**HISTORIC LANDMARK COMMISSION**  
**OCTOBER 22, 2018**  
**APPLICATION FOR A CERTIFICATE OF APPROPRIATENESS**  
**C14H-1977-0030**  
**Ben Pillow House**  
**1403 W. 9<sup>th</sup> Street**

Reconfigure the roofline to a single hipped roof; alter window and door openings on the rear elevation; change rear window openings on secondary elevations.

*Primary (north) façade and west elevation of 1403 W. 9<sup>th</sup> Street.*

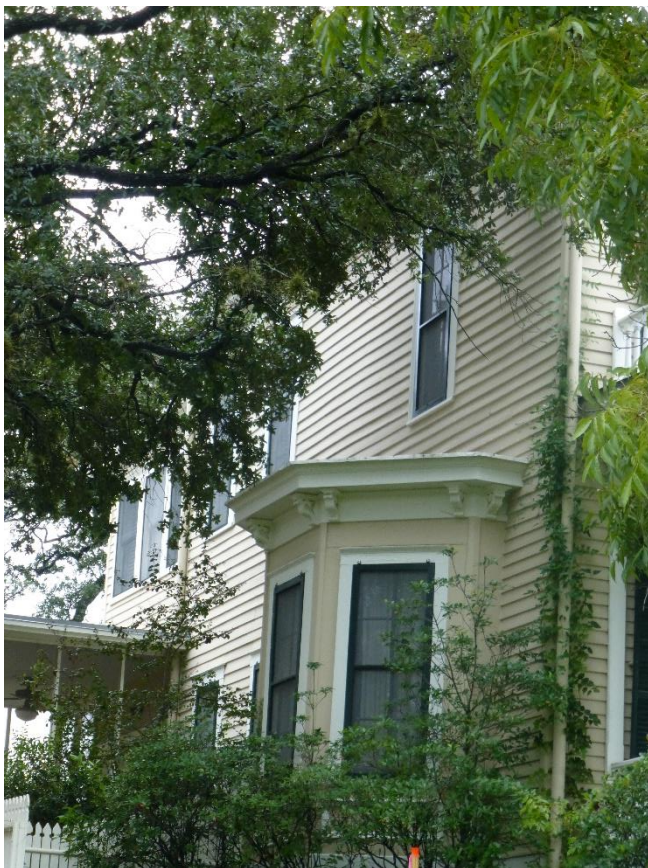
- *Do not destroy the distinguishing original qualities or character of a building, structure, or site and its environment. Avoid the removal or alteration of any historic material or distinctive architectural features.*  
 The restoration of existing historic features will help preserve the building character. However, the proposed project alters the historic roofline, including removal of the chimney; removes historic material from the rear elevation; and alters the side elevations. The roofline and chimney are distinctive character-defining features. There may be more flexibility with the rear elevation as a secondary feature, but it is visible due to the building's corner lot location. The project largely does not comply with this standard.

The proposed changes to the rear and side elevations of the building remove historic wall, window, door, and porch fabric. The changes to the windows are generally compatible with the historic character of the property in their material (clad wood) and recognize the multi-window pattern, but they disrupt the single and paired window pattern in the rest of the house. The change to the rear entrance is not compatible with the historic character of the building, particularly the removal of the entry porch. The project largely does not comply with this standard.

Recommend that the applicant return to the Commission with a design that preserves the chimney and original roofline, or a roofline that maintains a similar sense of development over time. Encourage the retention of historic window and door configuration and materials on the south elevation, but recognize that these changes are proposed to the rear elevation.

*Rear (south) elevation.*

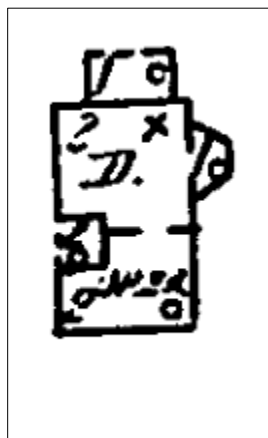
The committee felt that the proposed changes to the rear wall and roofline changed character-defining features of the house. It recommended preserving the existing rear wall configuration and roofline.
